07 Hard Landscape Strategy

A_RFMR_9253_C - Planning, Design and Access Statement

Pears Building

08 Soft Landscape Strategy: Amendment Response

Fig 15: Extract of Section 5.8 of the originally submitted Design and Access Statement - Hard Landscape Strategy - Proposed Amendment

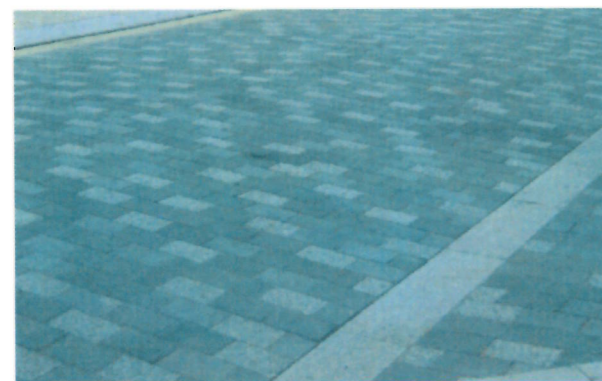
Material palette for hard landscaping retained - refer to material's key on the next page.

The UCL Garden and the Heath Strange Garden spaces to the east of the building are not part of this amendment.

North courtyard removed, but the proposed path adjacent to the North side of the building retained. The material palette for the path remains unchanged.

The two proposed car park spaces retained. The second car park space upgraded to become an accessible bay. A third accessible car park space added to the scheme in this location. The materials proposed for this area remain unchanged.

The materiality of the terraces and the aim to keep only a 150mm of the concrete visible remain unchanged. The low level terrace offering seating opportunities has been reduced to 450mm height.

The proposal to use brick on the retaining wall to the North-West corner remains unchanged in this amendment. The only changes constitute in adding a few "steps" to the already staggered arrangement of this wall.

The proposed landscape redesign aims to return the public footpath to its existing footprint as closely as possible, maintaining the minimum existing width in all locations.

Fig 19
Proposed Amendment - Soft Landscape Strategy
Refer to note 8.1

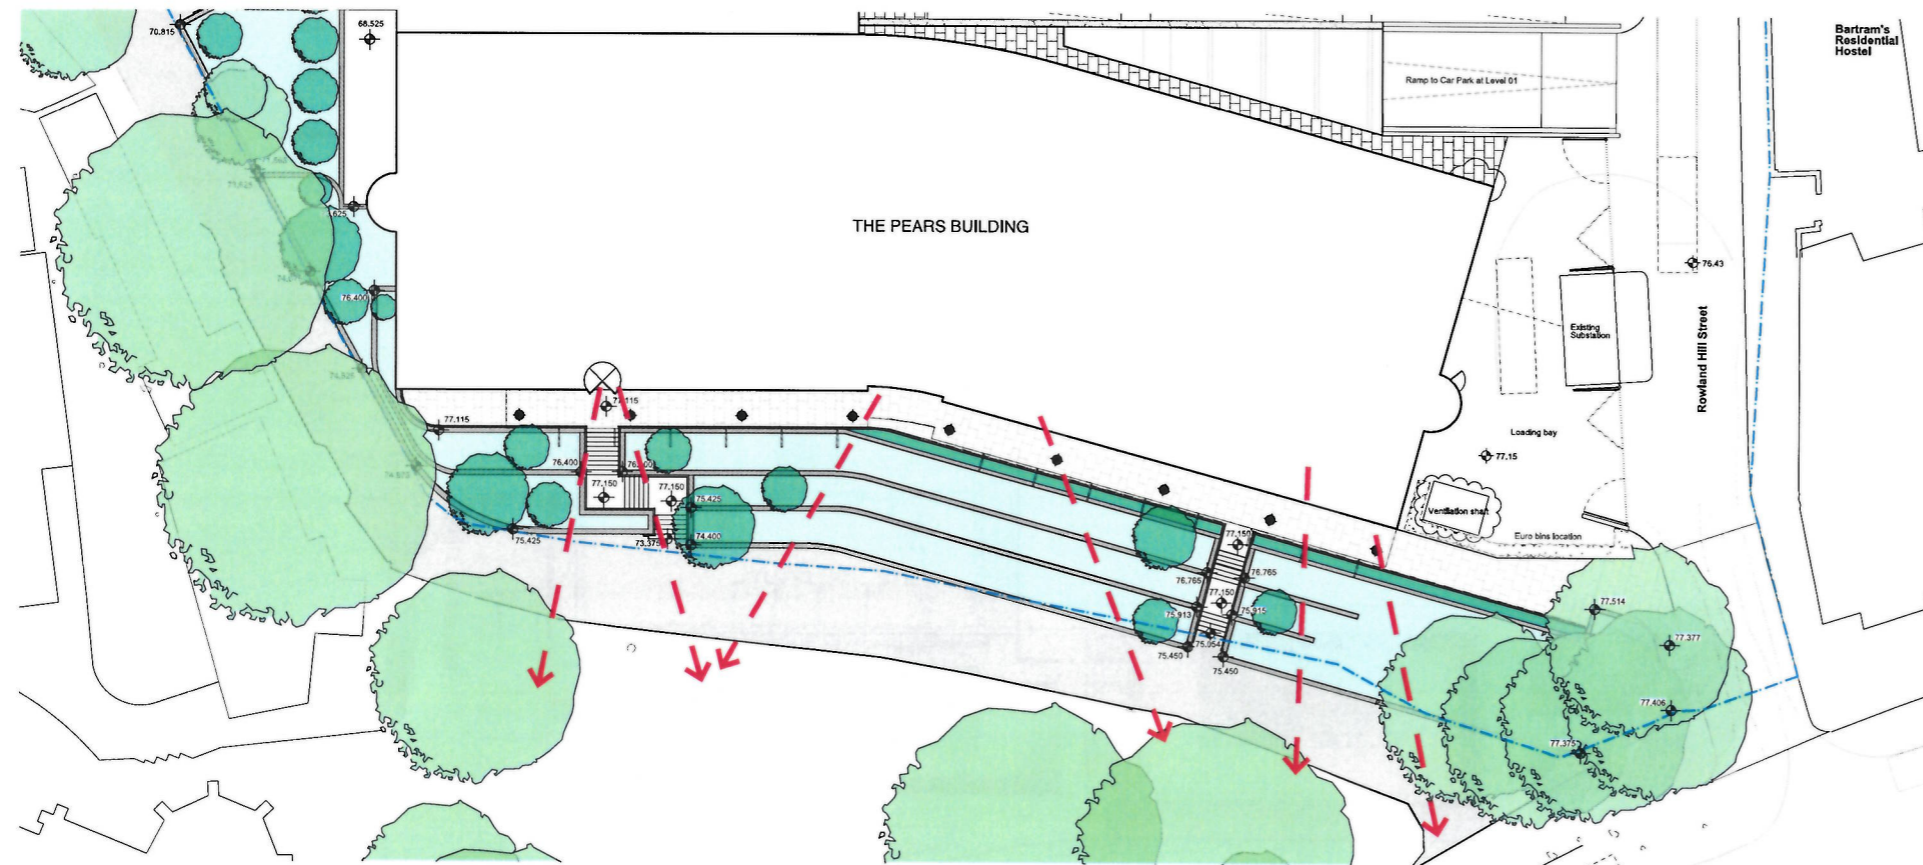
The consented scheme strategy for existing and proposed trees remains unchanged. Refer to Section 10 for the outline of the effect of the proposed landscape amendment on the existing trees.

As seen on the diagram above, the proposed amendment does not change the consented scheme concept to provide views out towards Rosslyn Hill, Hampstead Green and the new planting from the interior

The UCL Garden and the Heath Strange Garden spaces to the east of the building are not part of this amendment.

The detailed proposals for planting species to be submitted at a later date. The consented scheme concept to be followed, unless dimensional restrictions of available green space require changes to proposed species.
